Service Bulletin No: 91-001
Modification No: EC-19-0553

**AIR VEHICLE WIRING - GENERAL
IMPROVEMENTS TO THE AIRCRAFT ELECTRICAL HARNESS INSTALLATION**

PC-24 aircraft MSN 101 thru MSN 160.

To improve the electrical harness installation, at various locations throughout the aircraft, to prevent the possibility of the electrical harness chafing on the structure and/or moving parts.

Improvements to the electrical harness installation - Nose bay
Figure 1 (Sheet 2 of 5)

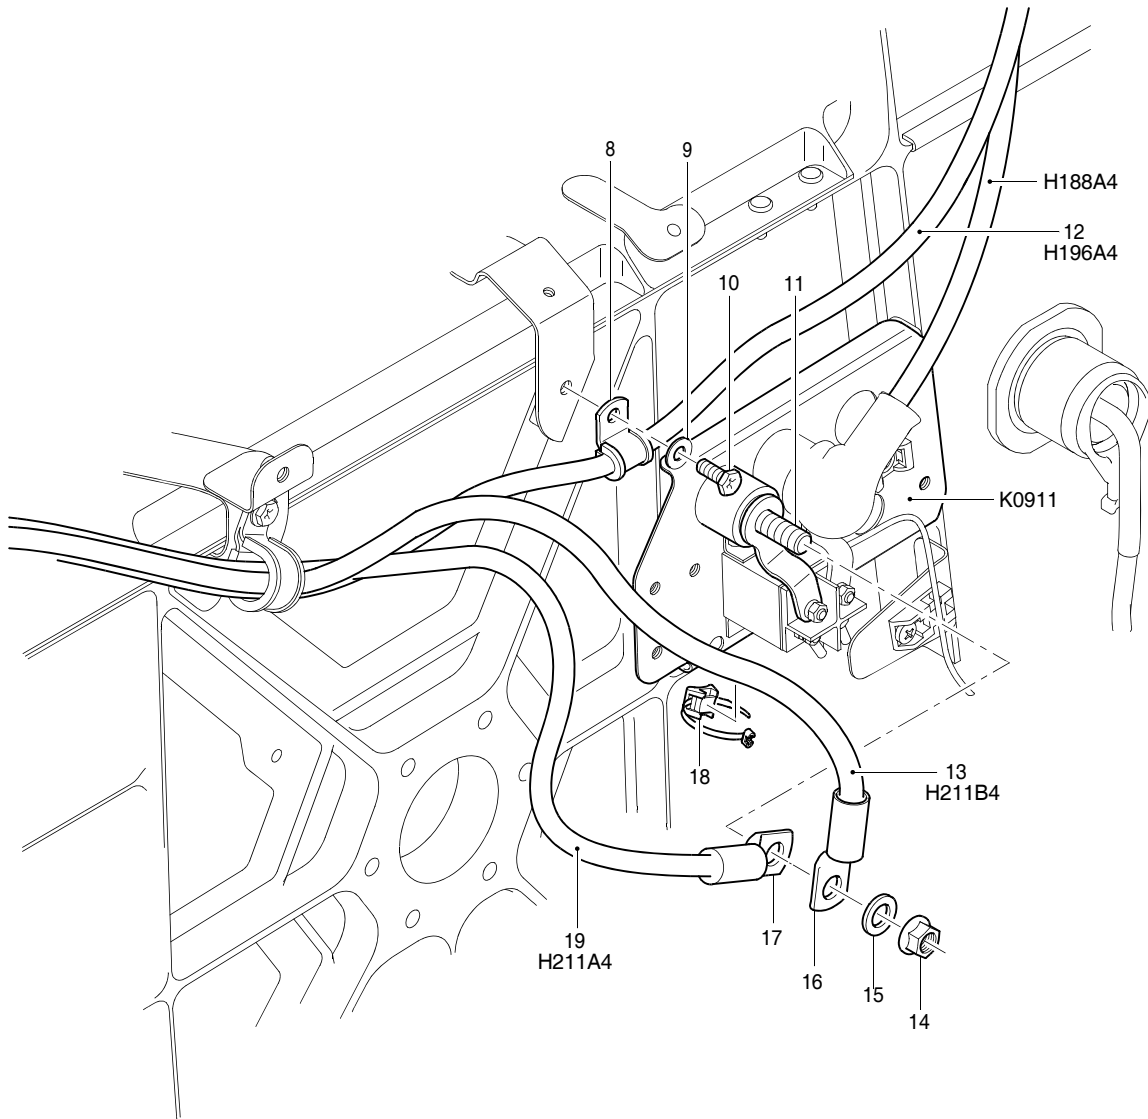
(1) Improvement to prevent the electrical harness from chafing on a screw head. Refer to Figure 1 (Sheet 2)

In front of the pressure bulkhead, FR 10, below the circuit breaker panel (PNL0913), at the aft cover plate:

- (a) Cut and remove the cable ties, as necessary, from the electrical harness (1) to get sufficient access to install the new spacer (5) (P/N 527.30.21.167) and the new saddle (6) (P/N 971.32.18.122).

- (b) Remove the screw (2) and the washer (3) from the aft cover plate (4). Discard the screw (2) and the washer (3).
- (c) Apply a thin layer of aeroshell grease 58 (Material No. P04-041) on the threads of the new screw (7) (P/N 932.35.10.117).

- (d) Loosely install the new spacer (5) (P/N 527.30.21.167), the new saddle (6) (P/N 971.32.18.122) and the new screw (7) on the aft cover plate (4). Make sure that the saddle (6) is correctly orientated for the cable tie installation.

Improvements to the electrical harness installation - Nose bay
Figure 1 (Sheet 3 of 5)

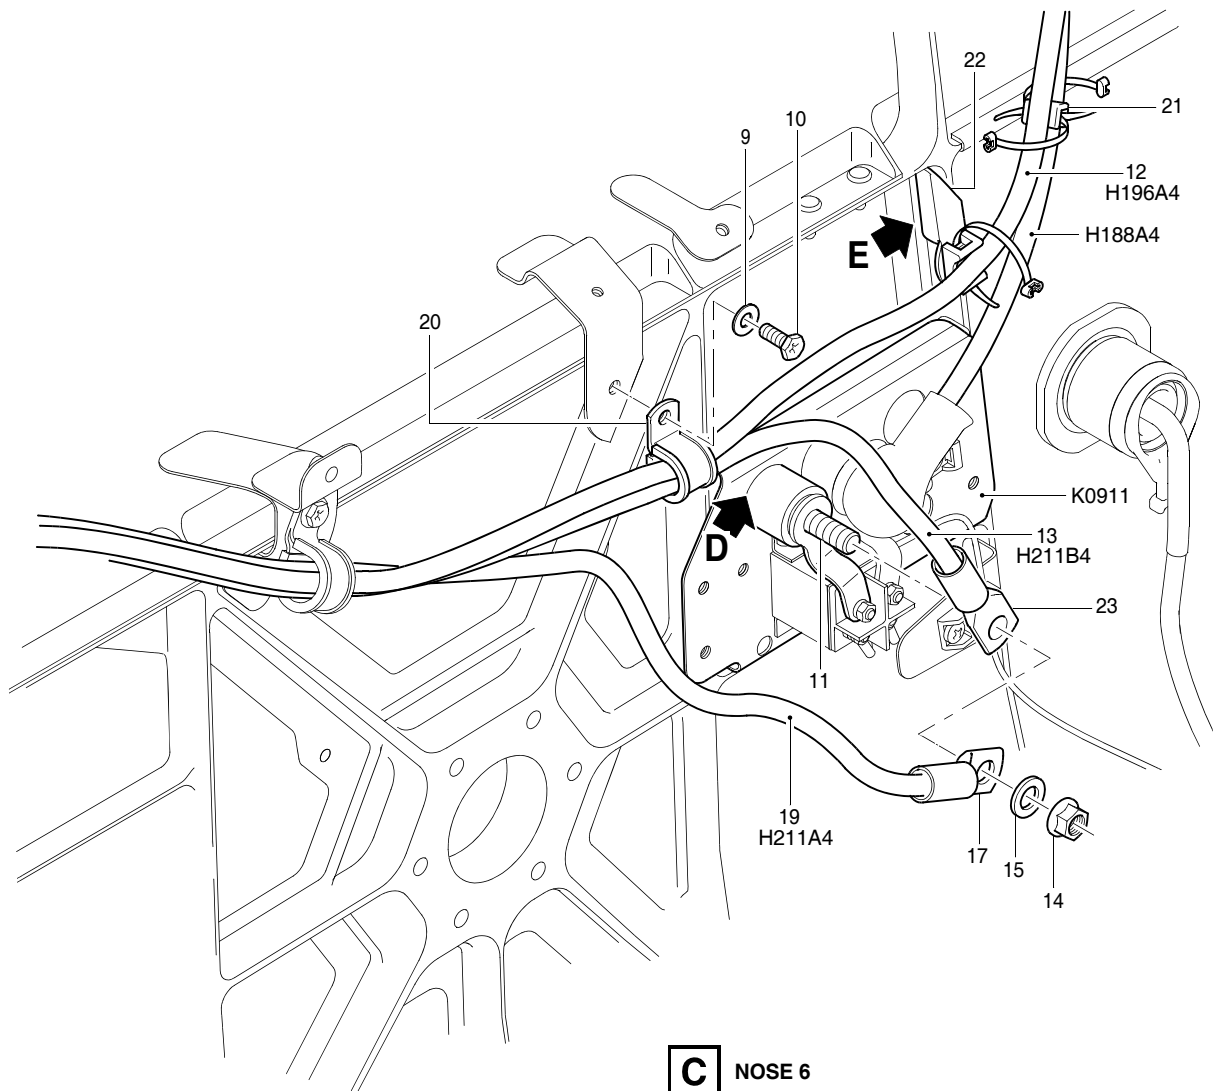
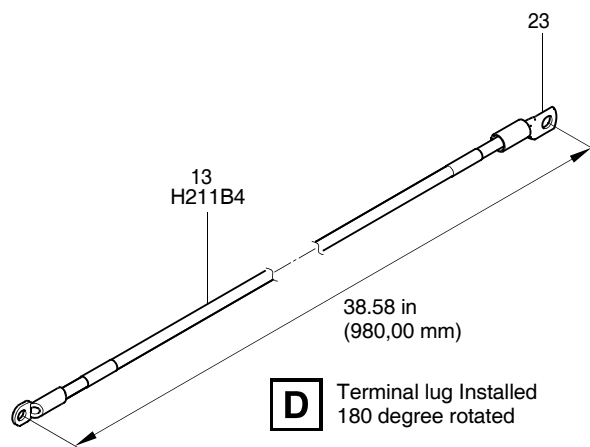
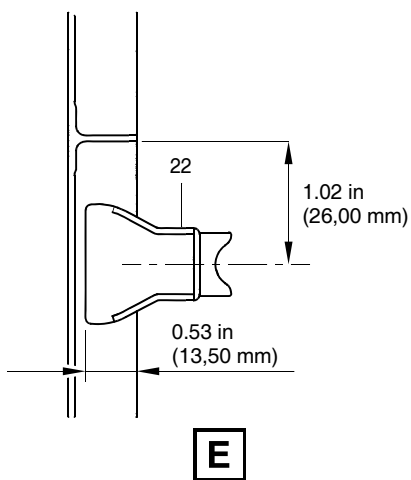
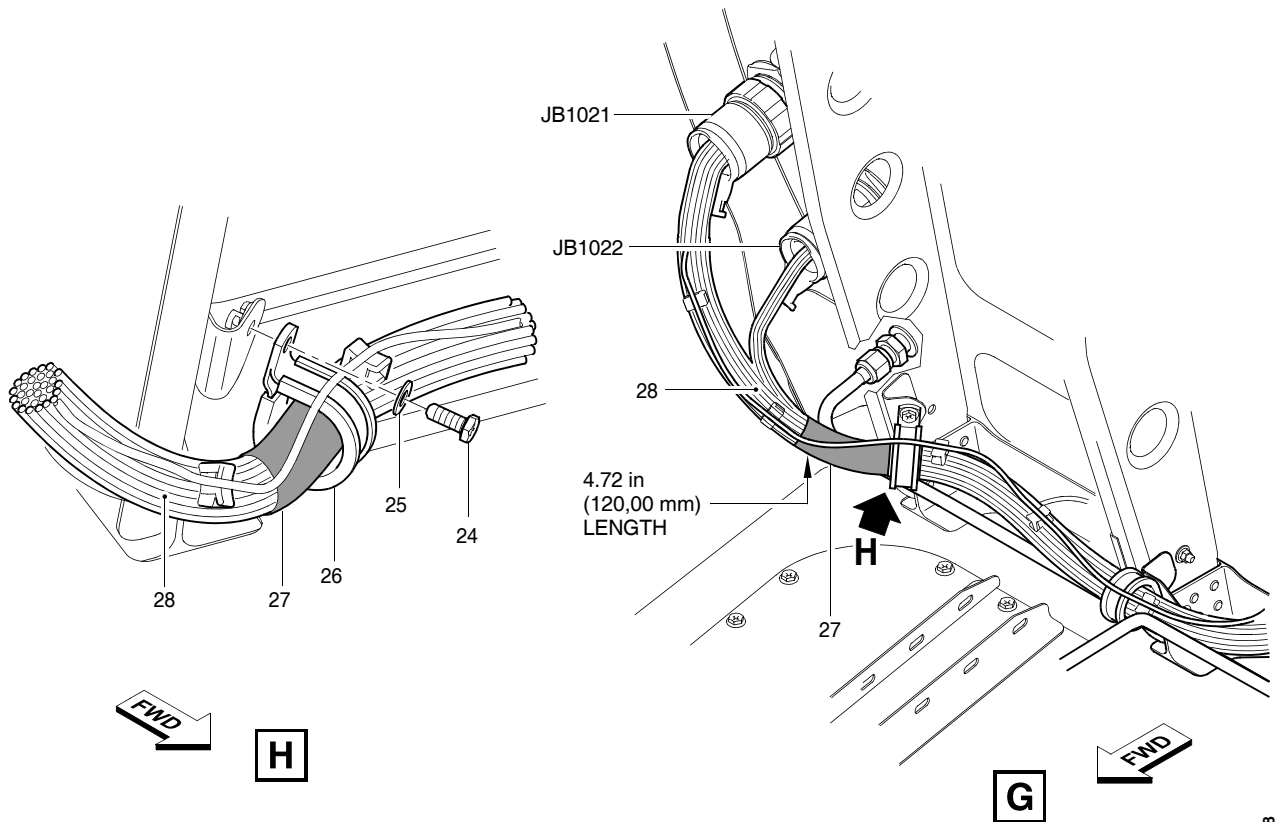
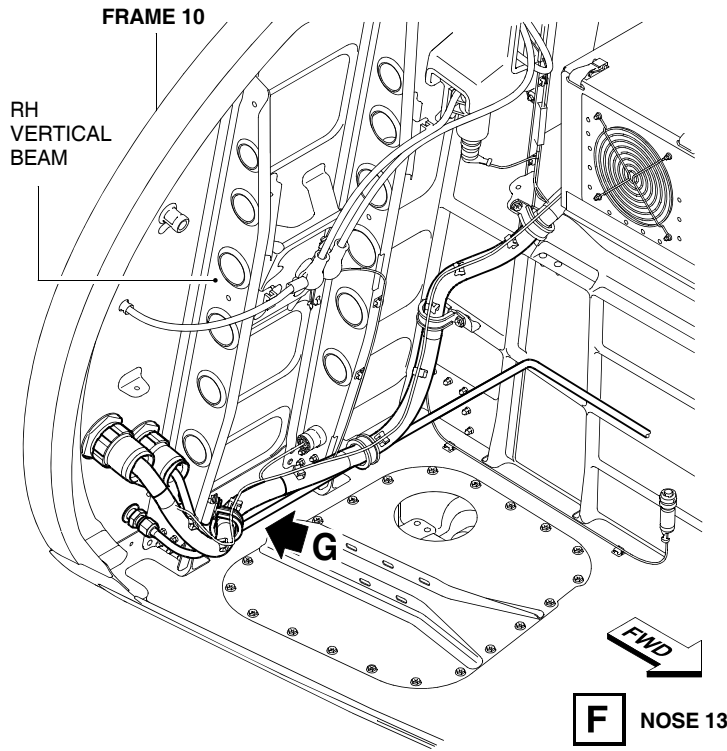
- (g) Use the applicable new cable ties (Material No. P09-005/P09-008/P09-014) as necessary, to:
- Attach the electrical harness (1) to the new saddle (6)
 - Replace any cable ties that you cut and removed to get access.
- (2) **Improvement to prevent the power cable from chafing on the screw head.**
Refer to Figure 1 (Sheet 3 and 4)

At the LH defog contactor panel (K0911):

- (h) Cut approximately 1.91 in (48,60 mm) off the length of the cable (13) (H211B4) (at the LH defog contactor panel (K0911) end), so that the full length of the cable is 38.58 in (980,00 mm). Refer to Figure 1 (Sheet 4, View D).

- (i) Cut back the necessary outer insulation from the cable (13) (H211B4), for the new terminal lug (23) installation.
 - (j) Use an applicable crimping tool and install the new terminal lug (23) (P/N 971.31.18.527) in the opposite orientation as it was before (180 degrees rotated). Refer to Figure 1 (Sheet 4, View D).

- (r) Torque the nut (14) to between 78 and 95 in-lb (8,8 and 10,8 Nm) plus the run-down torque. Make sure that the two terminal lugs (23) and (17) do not turn or bend. Refer to AMM, PC24-A-E20-20-0001-00A-040A-A.

Improvements to the electrical harness installation - Nose bay
Figure 1 (Sheet 5 of 5)

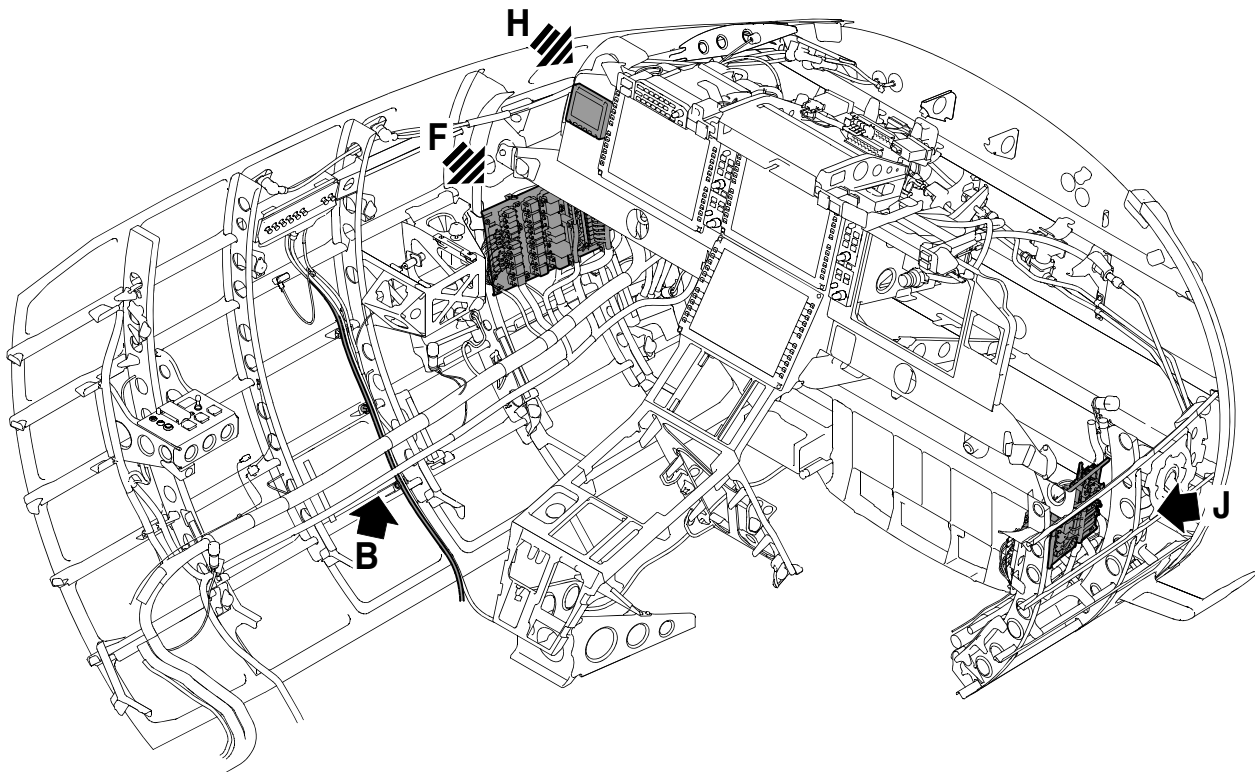
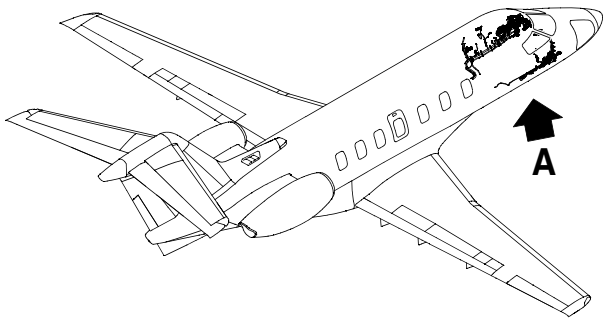
- (3) Improvement to prevent the electrical harness from chafing on the oxygen pipe.
Refer to Figure 1 (Sheet 5)

At the RH vertical beam below the electrical receptacles JB1021 and JB1022, and above the oxygen pipe:

- (c) Put the new protection sleeve (27) (P/N 917.96.92.155) (length 4.72 in (120,00 mm)) in position on the electrical harness (28). Make sure that it is positioned so that a minimum of half the width of the loop clamp (26) will cover it when installed.

Improvements to the electrical harness installation - Cockpit
Figure 2 (Sheet 2 of 6)

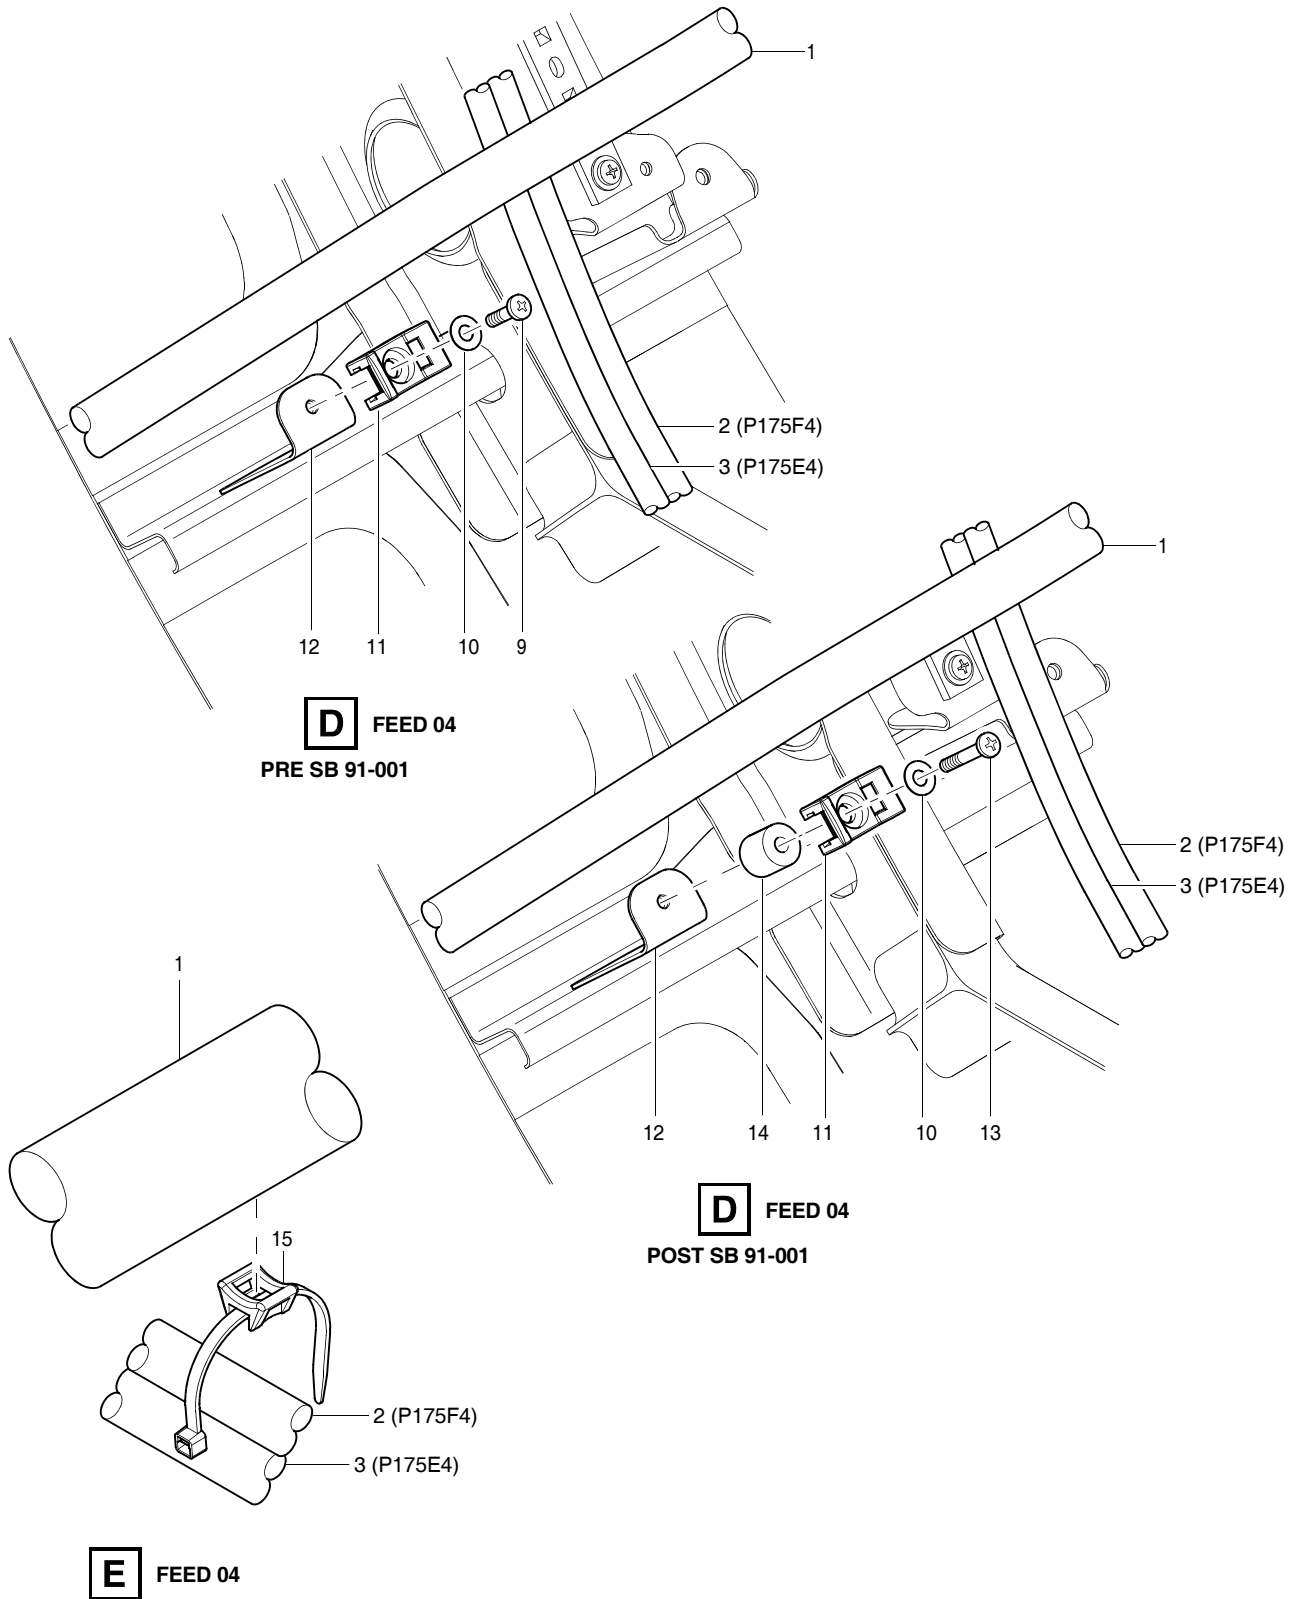
- (1) **Improvement to prevent the electrical harness from chafing on the oxygen pipe. Refer to Figure 2 (Sheet 2 and 3)**

On the LH side of the cockpit, aft of Frame 13, at the essential feeder 1 (P175F4) and the essential feeder (P175E4):

- (c) Remove the screw (4) and the saddle (5) from the upper attachment position (6). Discard the screw (4). Keep the saddle (5). Refer to Figure 2 (Sheet 2).

- (e) Loosely install the new roll (8) (P/N 557.10.21.563), the saddle (5) (that you kept) and the new screw (7) (P/N 935.63.31.118) at the upper attachment position (6). Refer to Figure 2 (Sheet 2).

Improvements to the electrical harness installation - Cockpit
Figure 2 (Sheet 4 of 6)

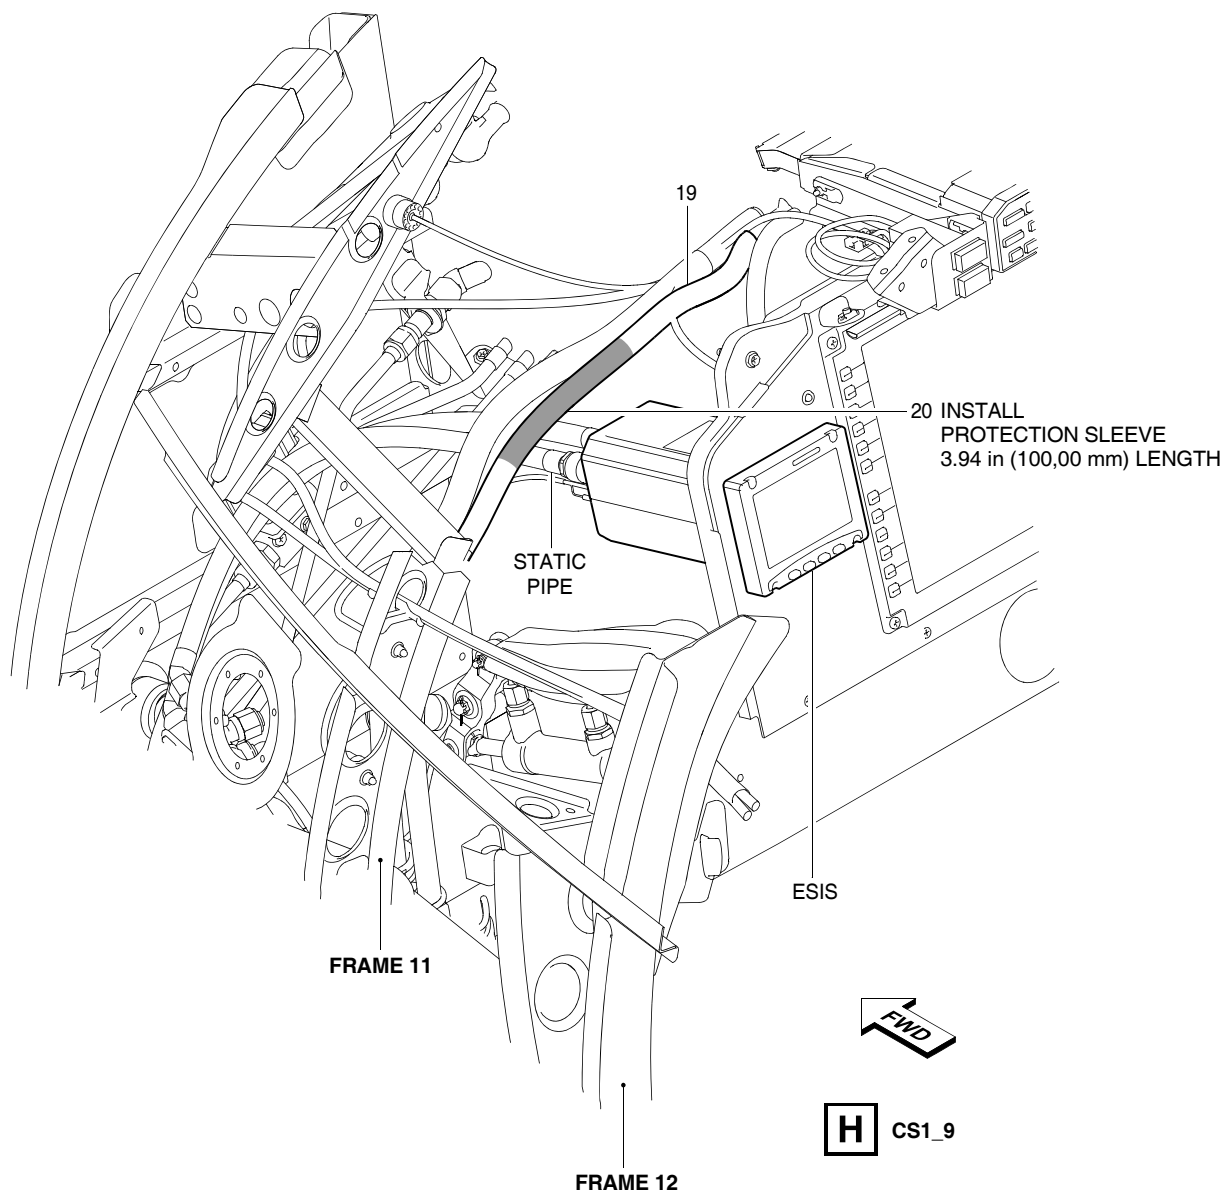
(2) Improvement to prevent the electrical harness from chafing on the hydraulic pipe. Refer to Figure 2 (Sheet 4)

On the LH side of the cockpit, aft of Frame 11, at the electrical harness that is connected to relay K311 at the rear of the pilots equipment panel (PNL1111):

- (a) Do a check to see if the distance from the electrical harness (17) to the hydraulic pipe (16) is ≥ 0.60 in (15,00 mm).

- (b) If the distance from the electrical harness (17) to the hydraulic pipe (16) is < 0.60 in (15,00 mm):
- 1 Cut and remove the necessary cable tie(s) so that you can modify the route of the electrical harness (17).
 - 2 Modify the route so that the:
 - Electrical harness (17) can be attached to the saddle (18)
 - Clearance from the hydraulic pipe (16) is a minimum distance of 0.60 in (15,00 mm).
 - 3 Put new tape (Silicone red, fiberglass) (Material No. P09-064) around the electrical harness (17) at the new installation position on the saddle (18).
 - 4 Use the applicable new cable ties (Material No. P09-005/P09-008/P09-014) to:
 - Attach the electrical harness (17) on the saddle (18)
 - Replace any cable ties that you cut and removed to get access.
- (3) **Improvement to prevent the electrical harness from chafing on the static pipe. Refer to Figure 2 (Sheet 5)**
